Subject: **Additional Information Response for the 401 Certification and Buffer Authorization** for the replacement of Bridge No. 14 located on NC 87 over Cane Creek, Alamance County
DWR# 20250885

Reference: On hold letter dated August 1, 2025 (DWR# 20250885)

Additional Information Response Package for BR-0060 (DWR #20250885)

LOCATION: REPLACE BRIDGE 000014 ON NC 87 OVER CANE CREEK

**BUFFER DRAWING
SHEET 2 OF 5**

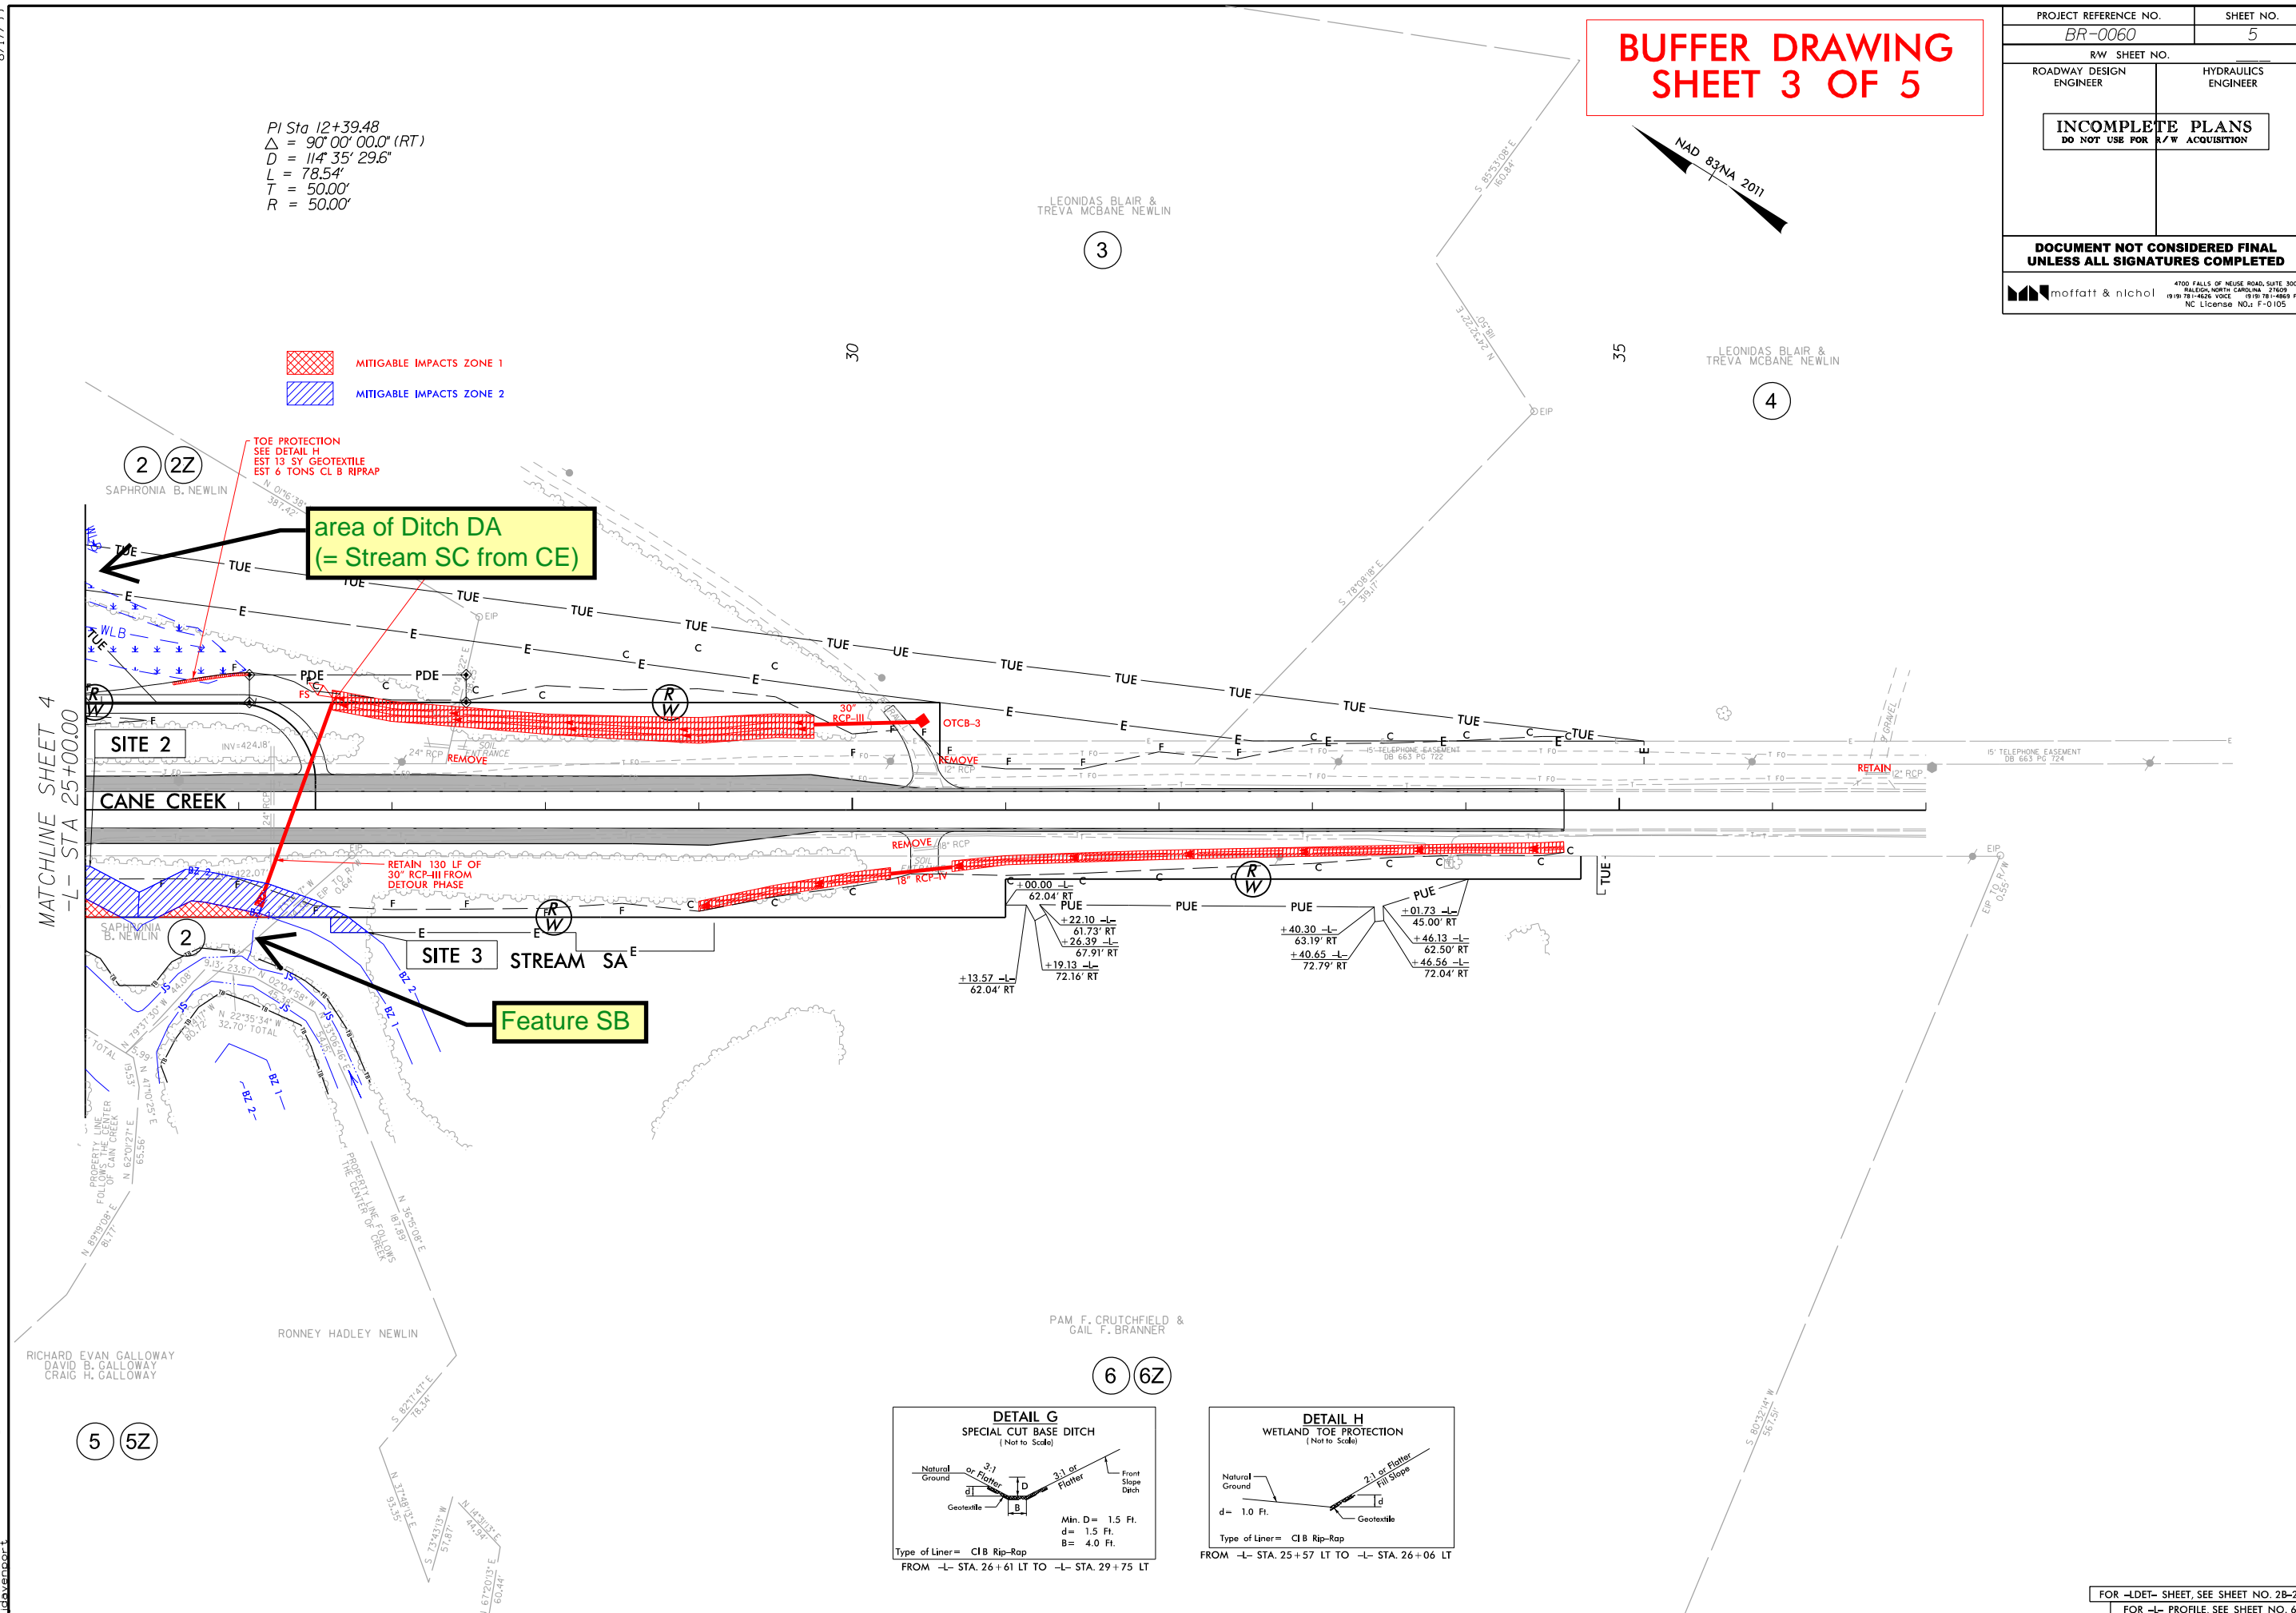
Please label stream SB and Stream SC throughout the permit and buffer drawings.

As described in the Response to DWR Comment 2, Stream SC has been updated to/labelled as Ditch DA (in attachment) and a label has been included on permit and buffer drawings.

Feature SB has been labeled on the permit and buffer drawings for reference. Please note that SB was determined to be ephemeral (Stream ID score of 15.5) and therefore was not labeled as a stream on the permit and buffer drawings but was identified as a drainage feature by Locations & Survey. The Stream ID Form for SB is included in the attachment in this submittal.

BR-0060 Soils Map

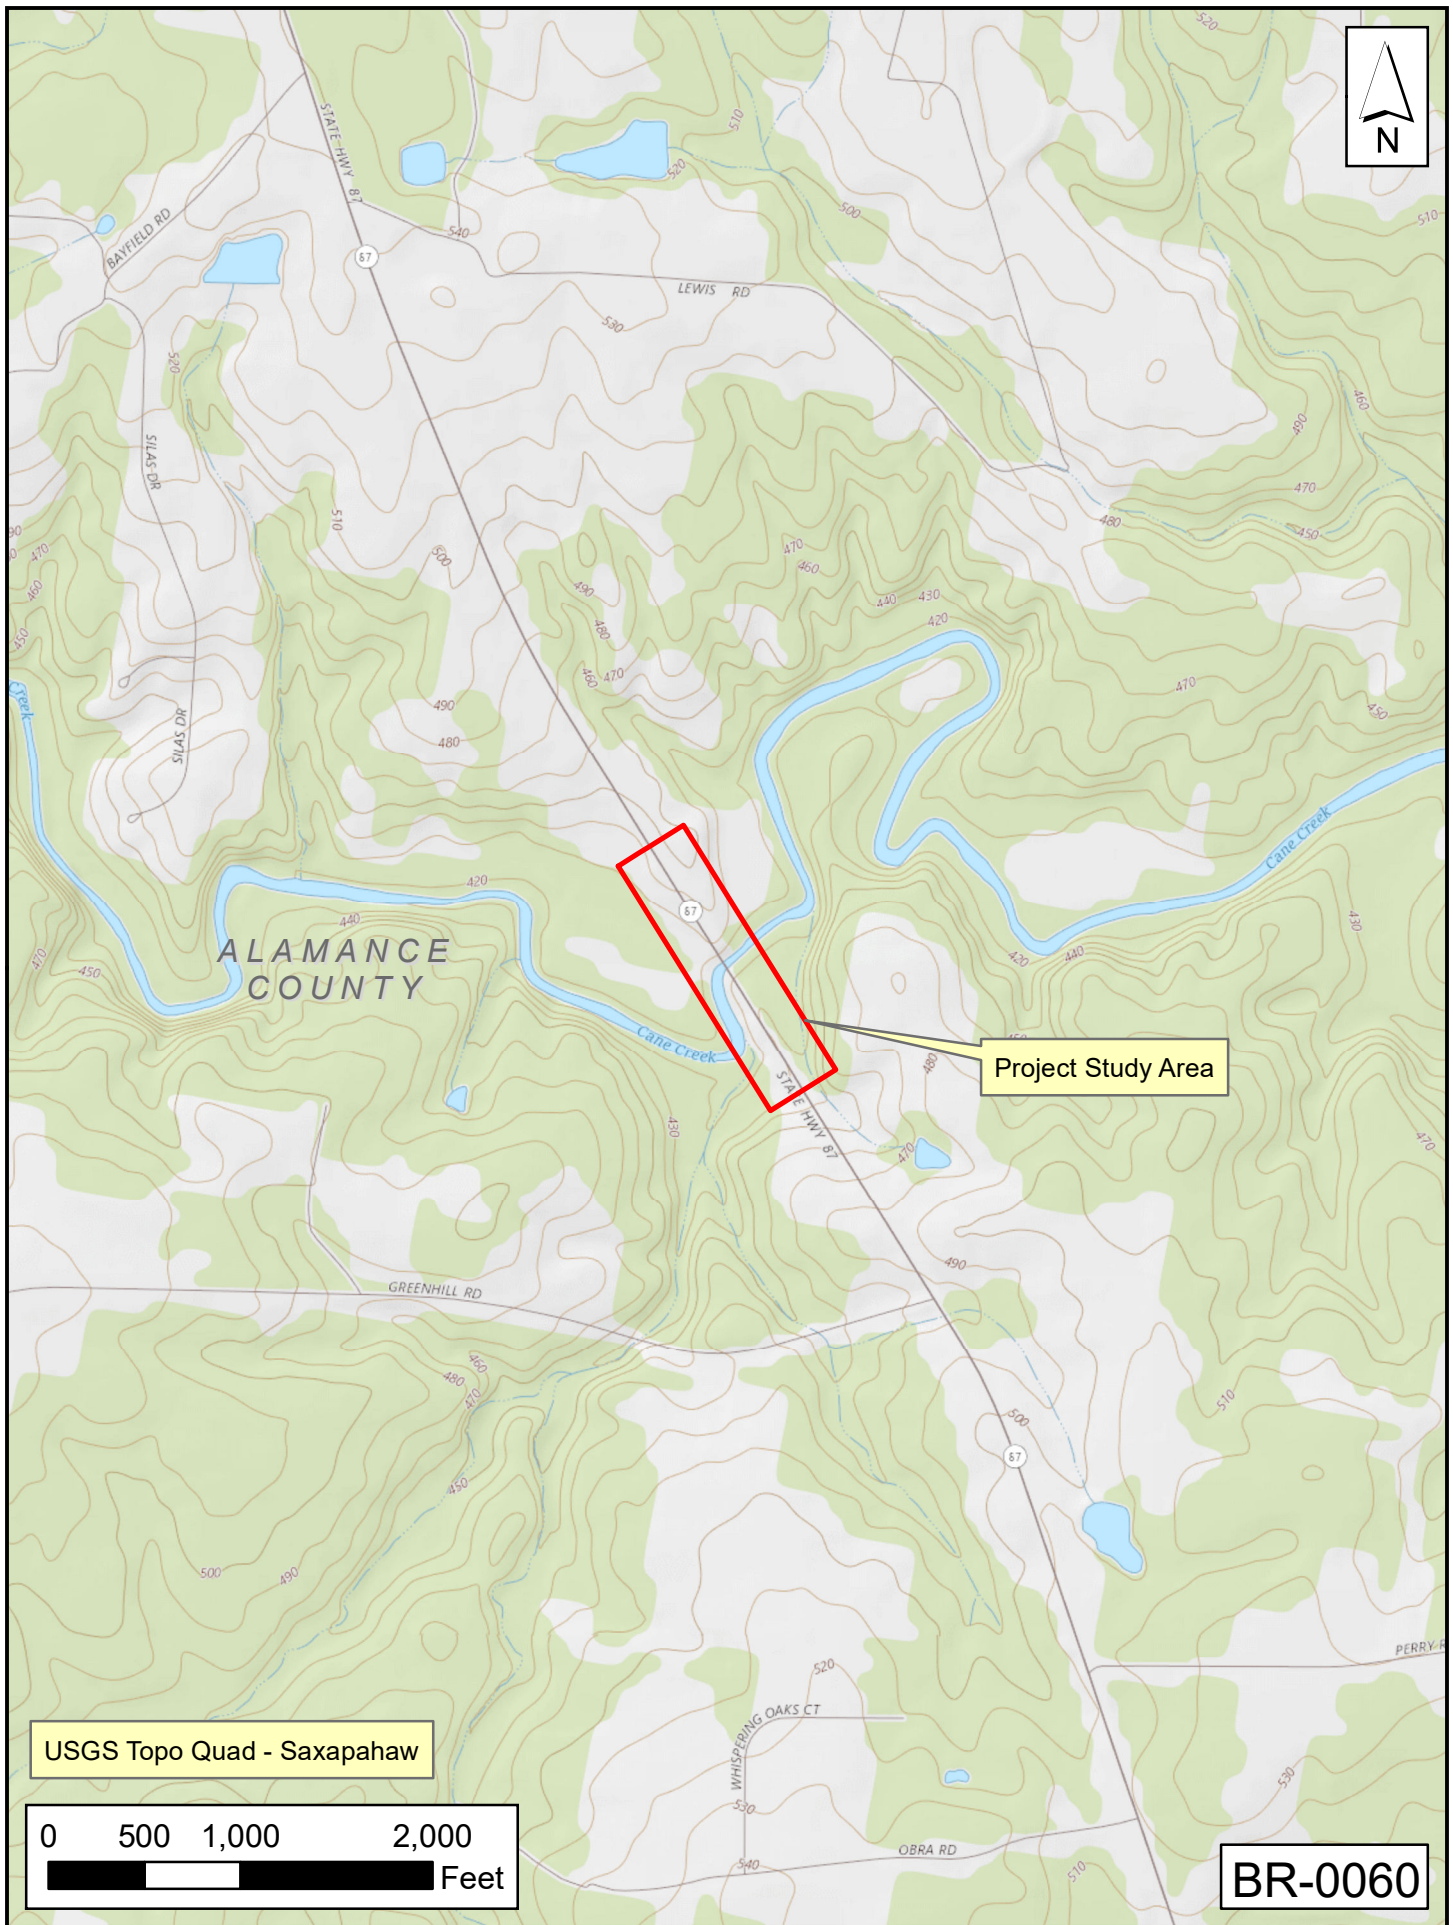
Provide a topographic map and soil survey of the revised project area.

A topographic Map and a Soil Survey Map are included in the attachment in this Response submittal.

Potential Jurisdictional Features Map

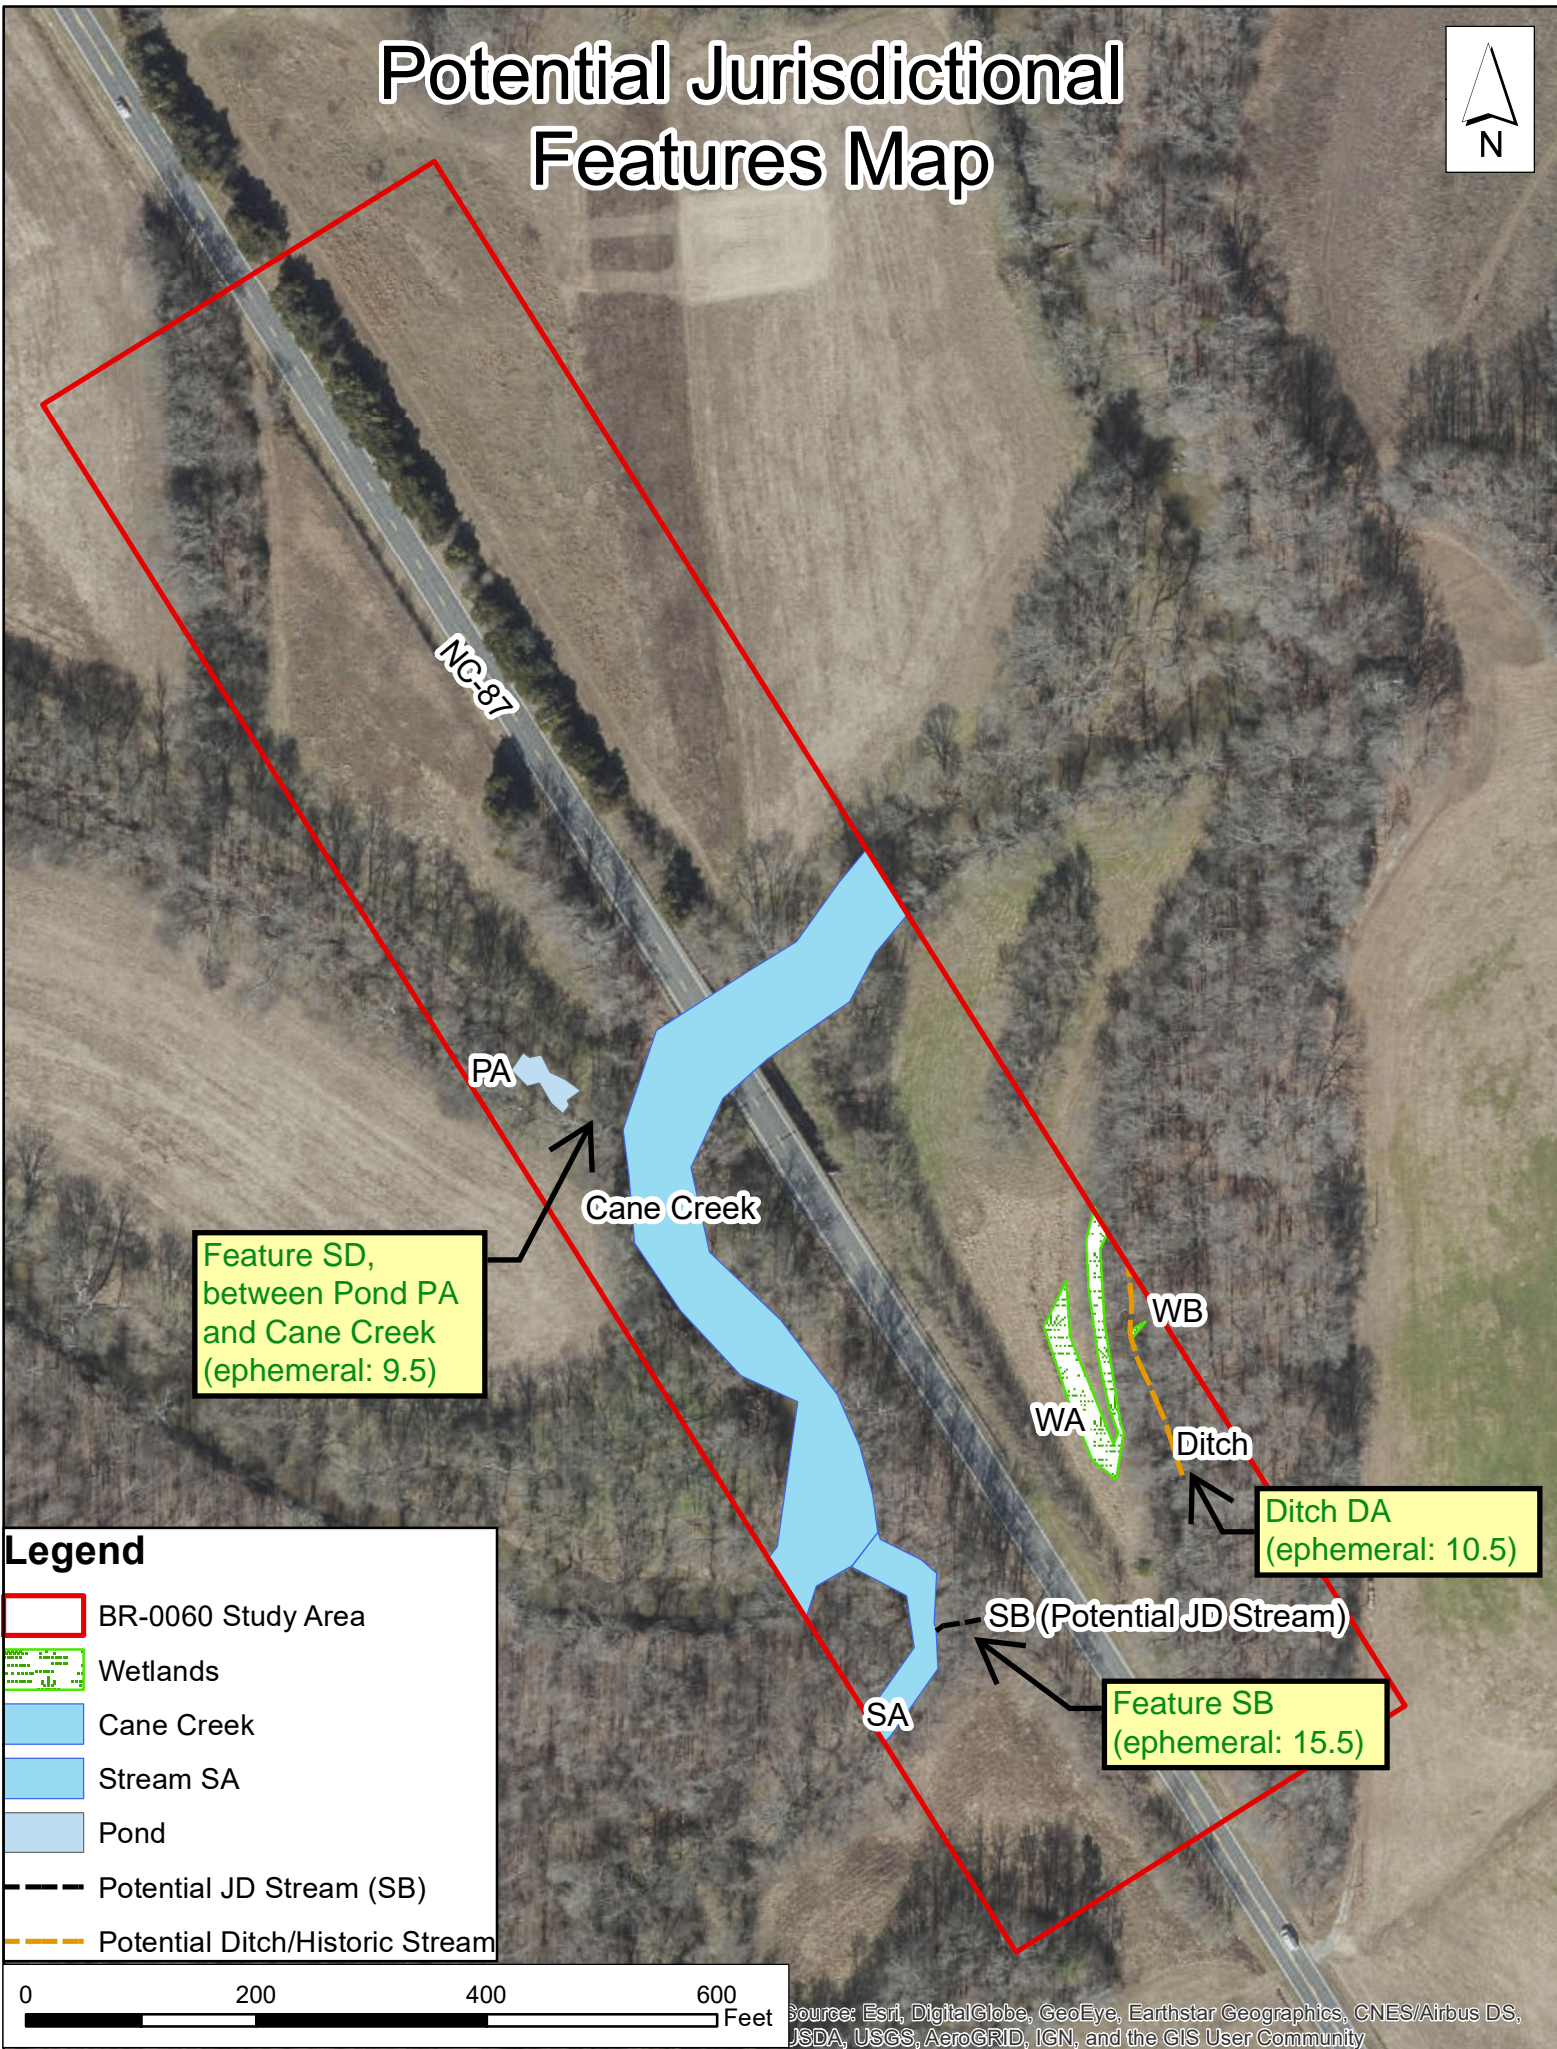
Based on the Jurisdictional Map, stream SB and SC are located on-site.

Stream SC does not appear to be depicted on the permit drawings.

Please note that in the attachment included with this Response is a Figure (*Potential Jurisdictional Features Map*) that identifies and re-labels Stream SC as **Ditch DA** (Stream SC => Ditch DA), along with a Stream ID Form for Ditch DA (score of 10.5).

There is also a Stream ID Form for “Stream SD” in the attachment, which is not depicted or labeled on the CE Document Figure. However, as noted on the Stream ID Form for Stream SD, the feature is located between Pond PA and Cane Creek, and was determined to be ephemeral (score of 9.5). A label has been applied to the *Potential Jurisdictional Features Map* for this feature, included in the attachment.

Stream SC was determined to be ephemeral (score = 10.5), and therefore not included in the permit and buffer drawings. As noted in prior responses, Stream SC is re-labeled as Ditch DA (SC => Ditch DA) on the Figure *Potential Jurisdictional Features Map* in the attachment.

Photographic Documentation for Ephemeral Channel
(Feature SD) connecting Pond PA to Cane Creek

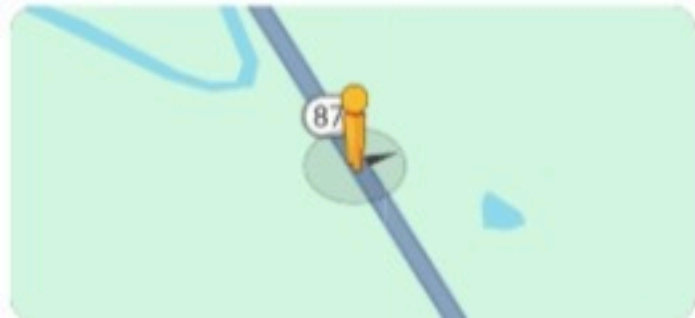
Please provide the Stream ID forms collected for Stream SB and SC.

Also as noted in prior comment responses, there also is a Stream ID Form for Stream SD, which is an ephemeral feature that is located between Pond PA and Cane Creek (see Response to DWR Comment 2). The attachment to DWR Comments includes photographic documentation of ephemeral feature SD.
